GUANAJIBO RIVER, PUERTO RICO

A LETTER FROM THE CHIEF OF ENGINEERS, DEPARTMENT OF THE ARMY DATED FEBRUARY 27, 1996, SUBMITTING A REPORT TOGETHER WITH ACCOMPANYING PAPERS AND ILLUSTRATIONS—RECEIVED IN THE UNITED STATES HOUSE OF REPRESENTATIVES NOVEMBER 12, 1996, PURSUANT TO SECTION 204 OF THE 1970 FLOOD CONTROL ACT (PUBLIC LAW 91-611)

Page
Letter of Transmittal	v
Comments of the Office of Management and Budget	vii
Comments of the Commonwealth of Puerto Rico	viii
Comments of the Department of the Interior	ix
Comments of the Department of Agriculture	xi
Comments of the Department of Transportation	xiv
Comments of the Environmental Protection Agency	xv
Letter to the Environmental Protection Agency	xviii
Report of the Chief of Engineers, Department of the Army	1
Report of the District Engineer:	
Syllabus	6

FIGURE 4-1

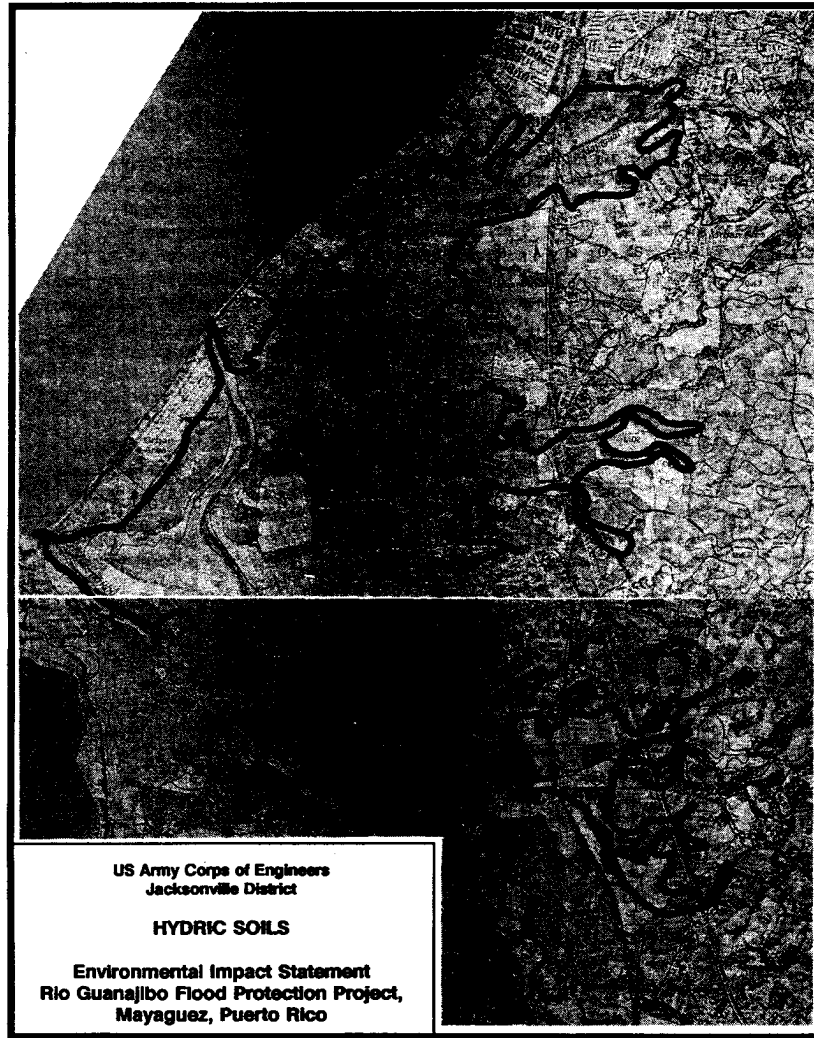
- Page 22: 5. Soils. "porus" is spelled "porous". Coloso series should read "somewhat poorly drained".
- Page 28: C. Land Use. The acreage of wetlands is high and does not agree with Table 6. Also, see comments on page 105 and Figure 4-1.

Page 28: C. Land Use. The acreage of wetlands is high and does not agree with the map. Also, see comments on page 105 and Figure 4-1.

Page 105. The Colosoide were originally on the hydric soils list. This statement will be corrected to reflect the change in the list. We will consider the use of your replacement for Figure 4-1.

Figure 3. Proposed mitigation alternative with connection to the Caño Corazones wetlands.

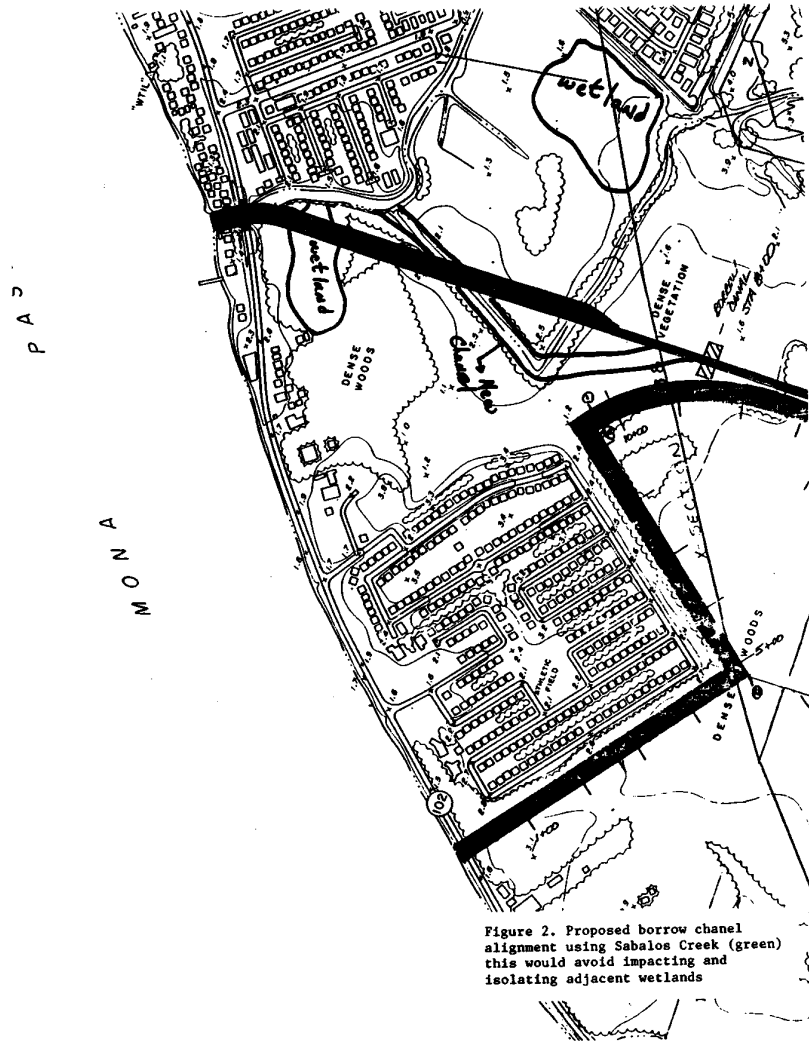
The Corps should consider the re-alignment of the levee borrow channel. The alignment should follow the course of the existing Sabalos Creek (Figure 2). This would avoid impacts to the adjacent wetlands areas. The proposed mitigation area is a strip along the confluence of the Rio Hondo and Guanajibo. We recommend that this area be extended so that it connects with Caño Corazones. This will provide a continuous wetlands area and provide additional flow into the existing Corazones wetlands (Figure 3). If this is not possible we recommend that the mitigation site be moved nearer the mouth of the Guanajibo so that it is contiguous to existing wetlands.

If the mitigation site is moved towards the river mouth (Figure 4) wetland creation as well as enhancement of existing wetlands could be carried out. Mangrove vegetation could be established in the lower portion of the site and Pterocarpus in the upper portion. Existing wetlands would be enhanced by increased flow.
